Conceptual Zoning Site Plan

Cumberland Parkway Site - Cobb County, GA

PETITION NO: Z-93

ZONING COMMENTS:

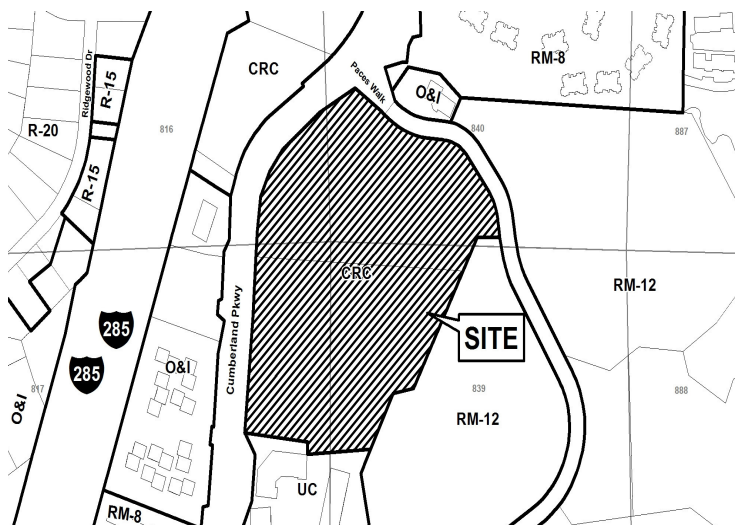
The proposed plan will require a contemporaneous variance to waive the front setback from the required 50 feet to 25 feet. The applicant also needs to reduce the 50-foot landscape buffer along the east and south property lines to allow the access drives.

- Provide comprehensive hydrology/stormwater controls to include development of out parcels.
- Submit all proposed site improvements to Plan Review.
- Any **spring activity** uncovered must be addressed by a qualified geotechnical engineer (PE).
- Structural fill _____ must be placed under the direction of a qualified registered Georgia geotechnical engineer (PE).
- Existing facility.
- Project must comply with the Water Quality requirements of the CWA-NPDES-NPS Permit and County Water Quality Ordinance.
- Water Quality/Quantity contributions of the existing lake/pond on site must be continued as baseline conditions into proposed project.
- Calculate and provide % impervious of project site.
- Revisit design; reduce pavement area to reduce runoff and pollution.

- No Stormwater controls shown _____
- Copy of survey is not current – Additional comments may be forthcoming when current site conditions are exposed.
- No site improvements showing on exhibit.

Recommend applicant verify that minimum intersection sight distance of 490' is available for Cumberland Parkway entrance. Recommend restricting right turns on red if sight distance requirement can not be achieved at the signalized intersection.

Recommend signalized entrance directly align with the development across the street on Cumberland Parkway.

Based on the above analysis, Staff recommends **APPROVAL** for residential portion of the application, **DENIAL** of the commercial portion in Parcel A, and deletion from the application of Parcels B, C and D, subject to the following conditions:

1. Final site plan be approved by the Board of Commissioners;
2. Maximum of 16 units per acre;
3. Variances requested in Zoning Comments section;
4. Water and Sewer Division comments and recommendations;
5. Stormwater Management Division comments and recommendations; and
6. Department of Transportation comments and recommendations.
